Forest Service

Subject: Land Stability of Twelve Mile Canyon Between Newfield Reservoir and Spring Hill

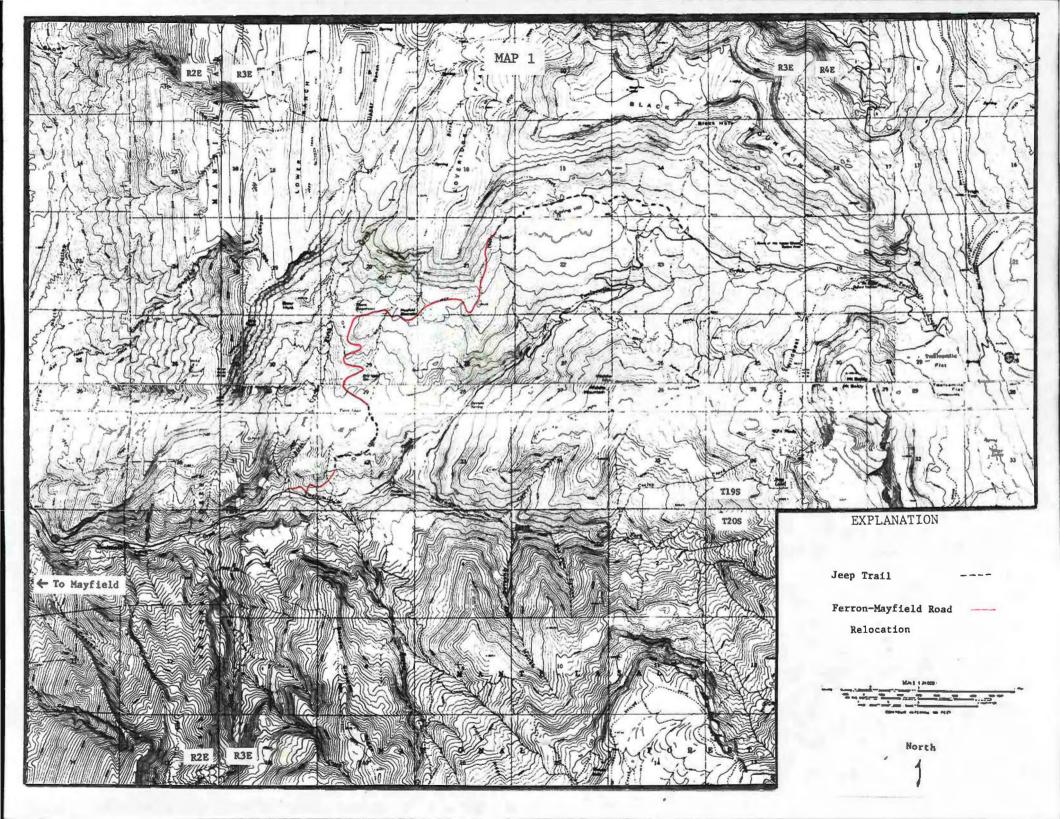
On September 10, 1984, I conducted a land stability field review of a portion of the proposed Ferron-Mayfield Road Relocation in Twelve Mile Canyon (Map 1) at the request of Holger Theobalt, Civil Engineer. The investigation was conducted in the area between Newfield Reservoir and Spring Hill. No concerns for stability were expressed for the remaining sections of the road relocation. Holger Theobalt accompanied me on the field examination.

The subject area is located in Section 21, T19S, R3E (Map 1). The present Ferron-Mayfield Road located near the bottom of Twelve Mile Canyon was extensively damaged by landslides and stream bank failures in the springs of 1983 and 1984. Relocation of the road in the subject area is now being evaluated to re-establish surface access.

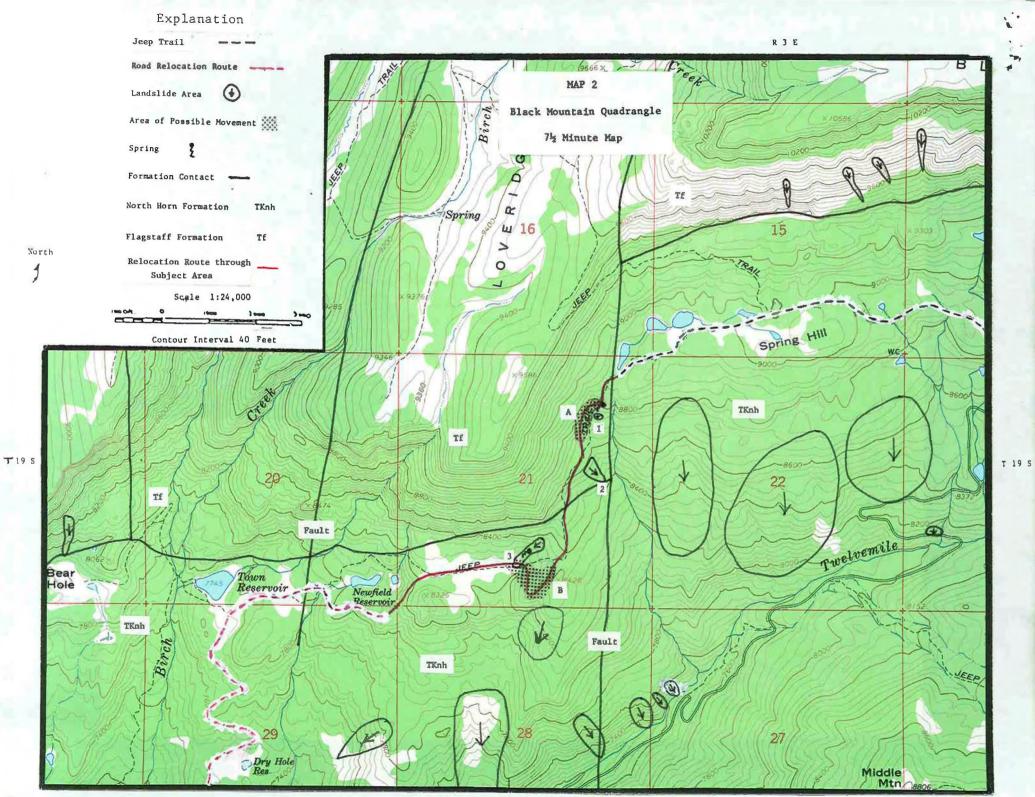
There are three small landslides along the road relocation route between Spring Hill and Newfield Reservoir (Map 2). These slides are earth slumps which move along a concave surface of rupture with the main body of unconsolidated material tilted back toward the slope and dropping vertically at the head. These slides formed in the spring of 1984. The Ferron-Mayfield Road relocation as proposed has avoided slumps one and two but cuts the toe of slump three. There is spring seepage originating from the toe of slump three. Slump two appears to have found a stable center of gravity and will most likely not continue to fail further up slope.

There are two areas (A and B) which have the highest potential for slope instability (Map 2). These areas are located on well vegetated, north or east-facing steep slopes. In both areas there is soil creep occurring at an estimated rate of 2 inches per 20 years as evidenced by tree deformation. The subject area receives an average annual precipitation of 30 inches. The total 1983 annual precipitation at the Manti City monitoring station was 172% of the average annual precipitation for that station. The Manti Station is the nearest monitoring station to the subject area. The soils in Areas A and B have remained wet throughout much of the summer due to surface runoff.

There is a spring flowing from the fault zone in Area A. Groundwater originating from precipitation and snowmelt on Black Mountain and surface water from the sag ponds on Spring Hill may be migrating downslope along the fault plane into Area A. A small crack approximately 20 feet long and less than one-fourth inch wide was observed running parallel with the slope contours in Area A in the relocation route.
